**MINISTRY OF TRANSPORT, WORKS, LANDS
AND PHYSICAL PLANNING**
HALIFAX STREET
KINGSTOWN
ST. VINCENT & THE GRENADINES

**RE: IMPROVEMENT TO ARNOS VALE SPORTING COMPLEX – SUPPLY AND DELIVERY OF REPLAY
SCREEN: ADDENDUM #1**

Arnos Vale Sporting Complex – Site Plan

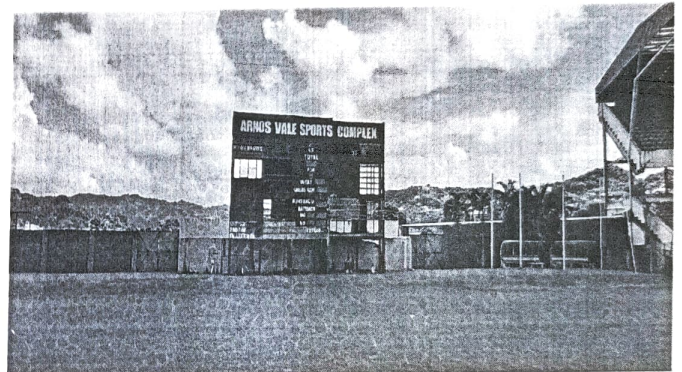
2. Table on page #25 – Location of Replay Screen

The desired placement of the one (1) replay screen is the support structure of the current scoreboard to be rehabilitated. See below screenshot "Screenshot 2023-08-31 093207.png".
Page 24 of the bidding document "Section IV: Schedule of Requirements" has the instructions for filling the table on page 25.

Display Screen Location
